NSTX Upgrade

OH Coaxial Cable and Embedded Leads

ADDENDUM to NSTXU-CALC-133-07-00

22 August 2015

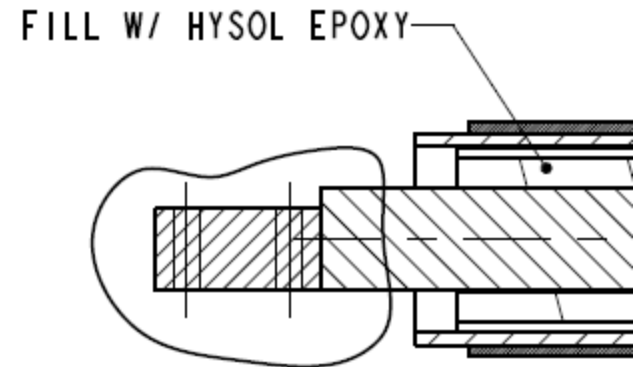
On page 28 of Mike's calculation, the following statement is made:

"In the region of the coaxial cable, the total forces on the inner and outer conduction balance each other. In this way, even though there are local compressive and tensile stresses in any plane of the coaxial cable, there is no net beam bending."

The drawing says fill with epoxy

Steve and Neway say it hasn't been filled, and Neway says that the total radial clearance of .02 is good Enough.

My Conclusion:

To avoid lift-off on the bolted connections, it should be filled.

Without Epoxy Fill and .01 inch gaps

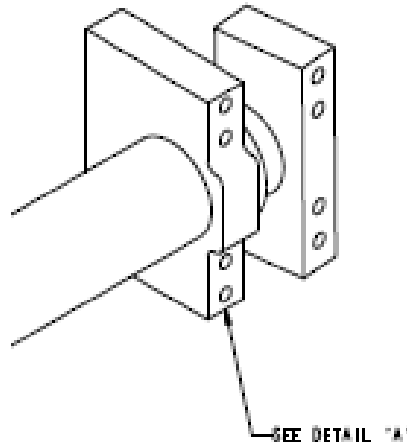
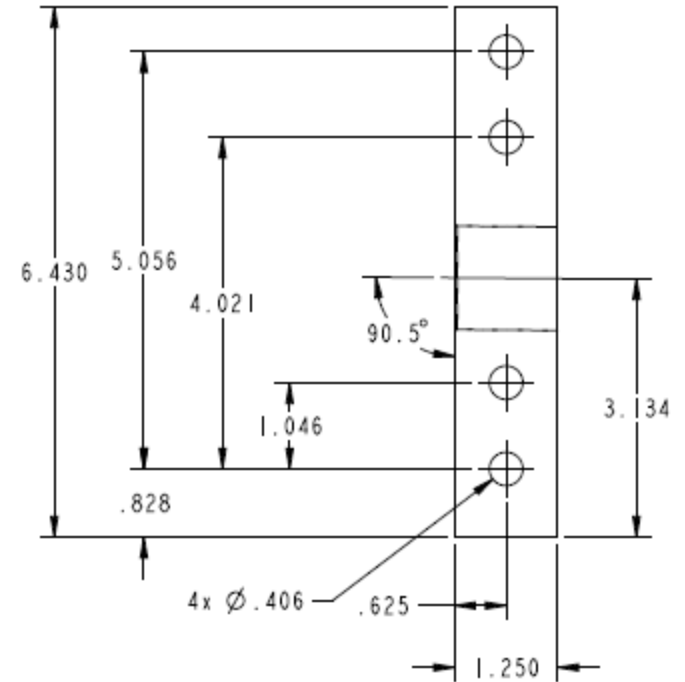
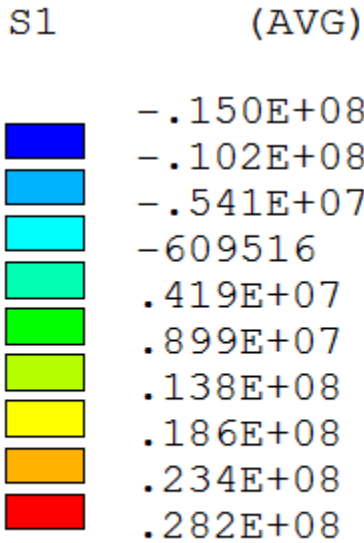
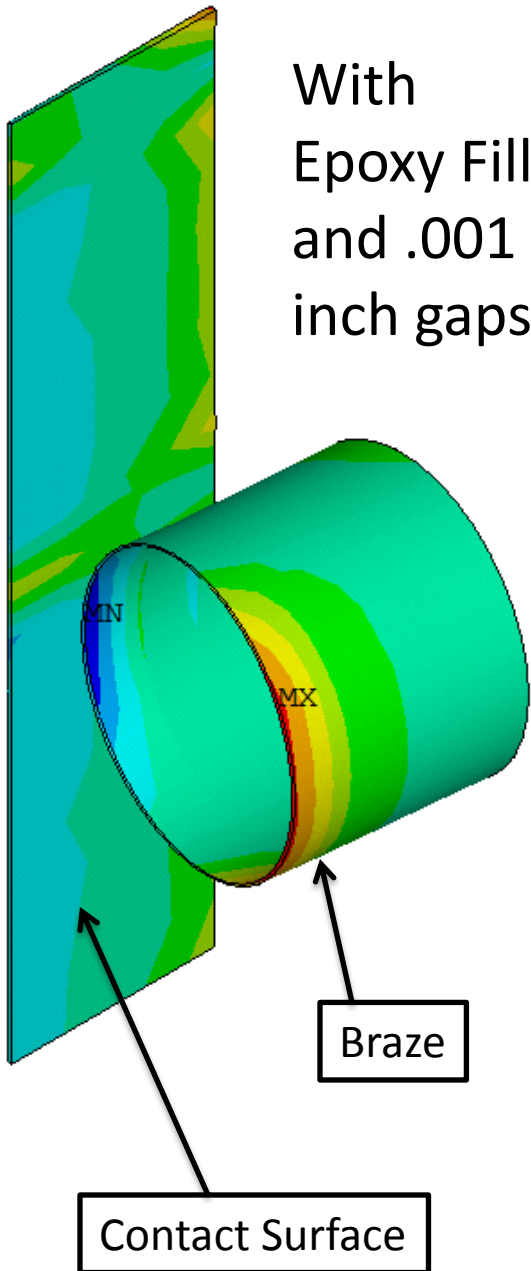
Preload Compressive stress is supplied by 4 3/8 bolts. They would be tensioned to $\sim 20\text{ksi} \cdot .0773\text{in}^2 = 1546$ lbs

Four of them would produce a compressive pressure of $4 \cdot 1546 \cdot 4 / 1.25 / 6.43 = 769$ psi or 5.3 MPa. The peak tension stress under load is 13.8 Mpa=2001 psi

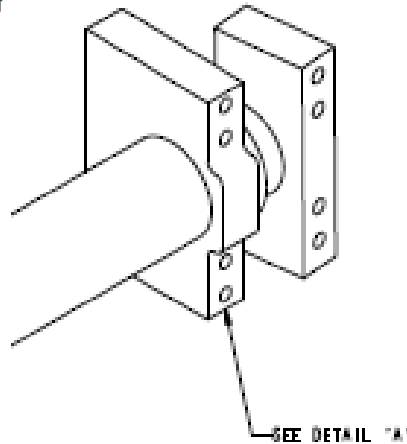
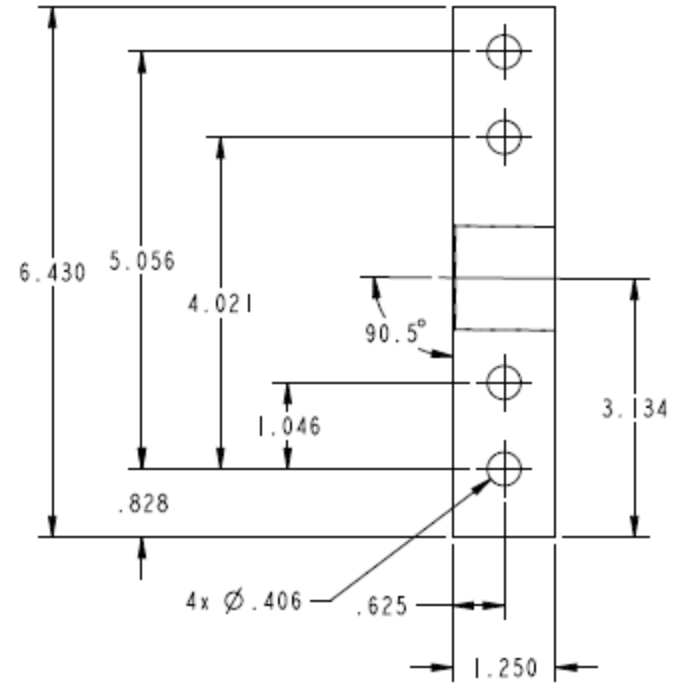
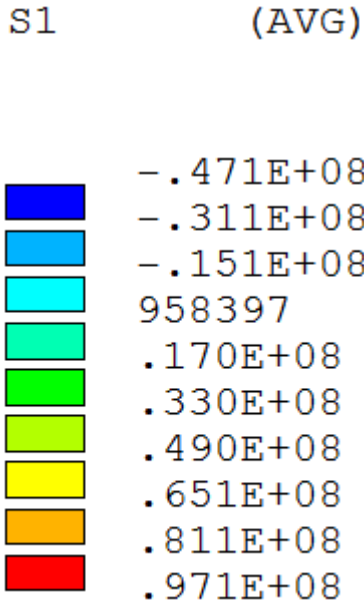
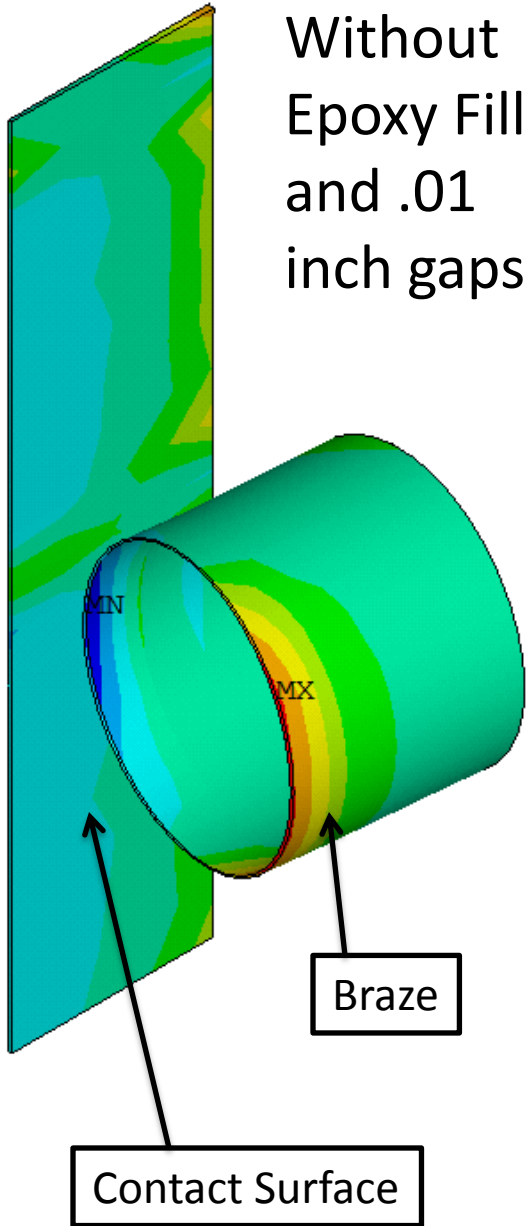
Preload Compressive stress is supplied by 4 3/8 bolts. They would be tensioned to $\sim 20\text{ksi} \cdot .0773\text{in}^2 = 1546\text{ lbs}$

Four of them would produce a compressive pressure of $4 \cdot 1546 \cdot 4 / 1.25 / 6.43 = 769\text{ psi}$ or 5.3 MPa. The peak tension stress under load is 49 Mpa=7106 psi

With
Epoxy Fill
and .001
inch gaps

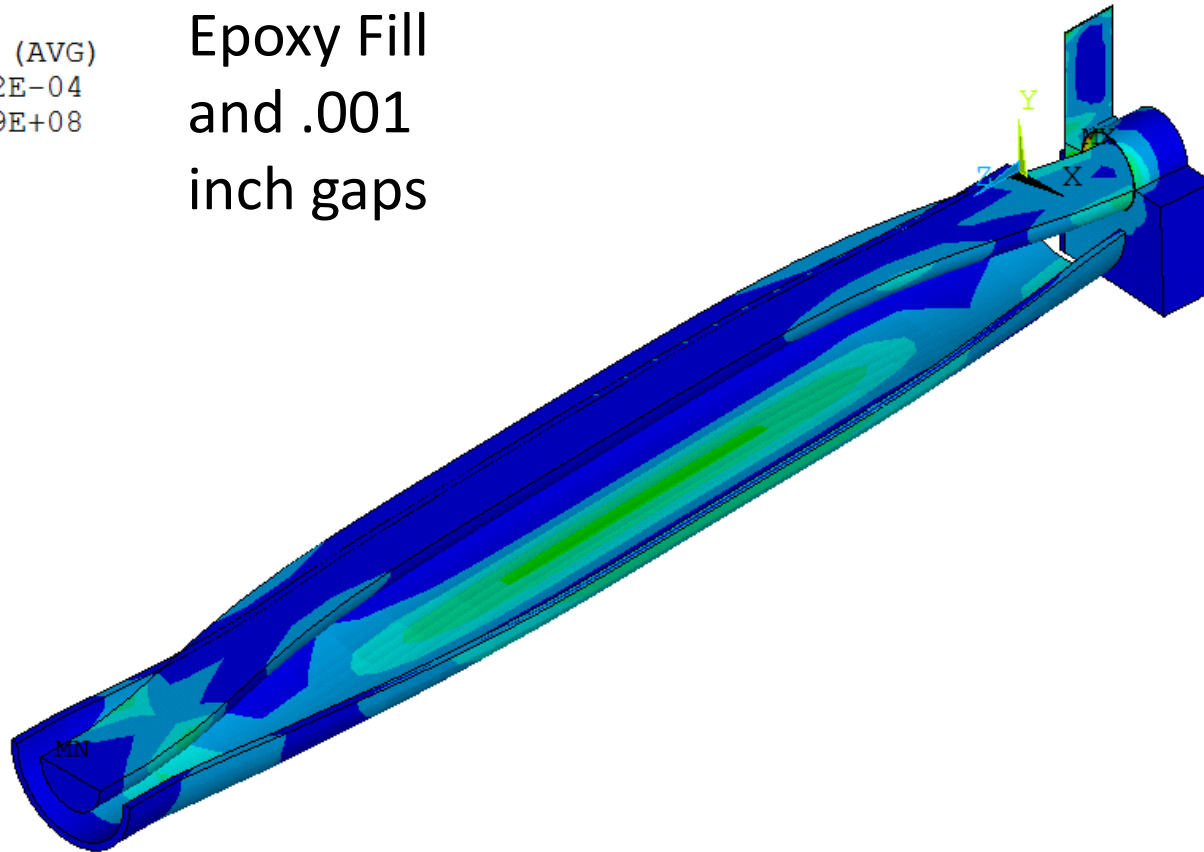
With
Epoxy Fill
and .001
inch gaps

Current Density Check

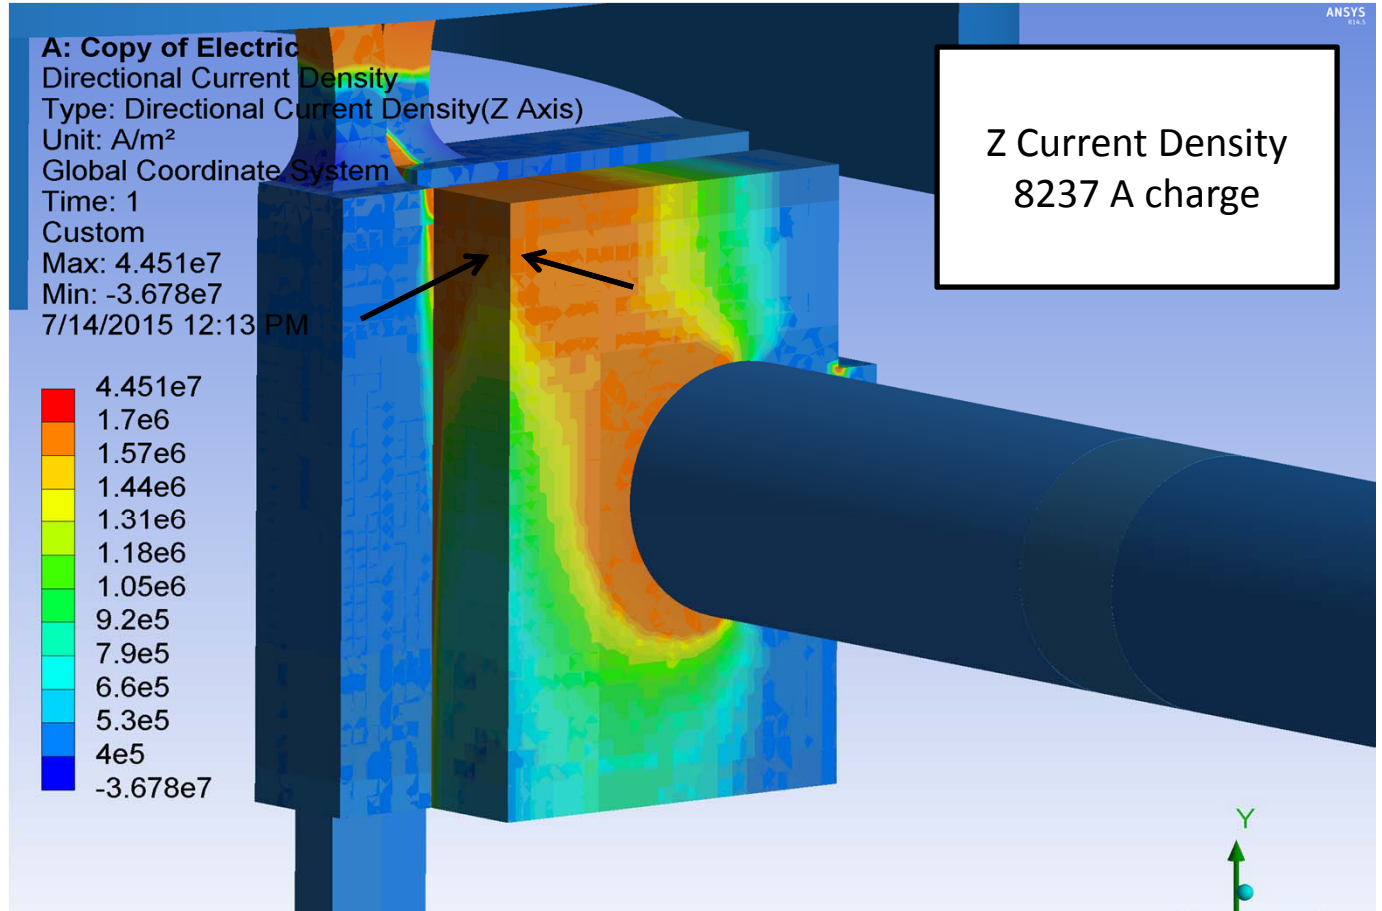
Andrei took Mike Mardenfeld's electromagnetic model and plotted up the current density at the upper corner of the contact surface. I assumed the contact was good and the pressure was just beyond the "knee" of the contact resistance curve. That gave me a voltage across the contacts (the two arrows) of $6.36e-6V$ for 69 amps. In the contour plot, the OH side block is shown removed. From the bluing, we may not have full contact where the measurements is being made, but the contact is good around the bolts very near where your measurement is being made. -Peter

$$V = 1.57e6 \text{ A/m}^2 * .75e-6 \text{ Ohm-in}^2 / 39.37^2$$

$$= 7.597e-4 \text{ Volts for 8237amps}$$

$$= 6.36e-6 \text{ V for 69 amps}$$
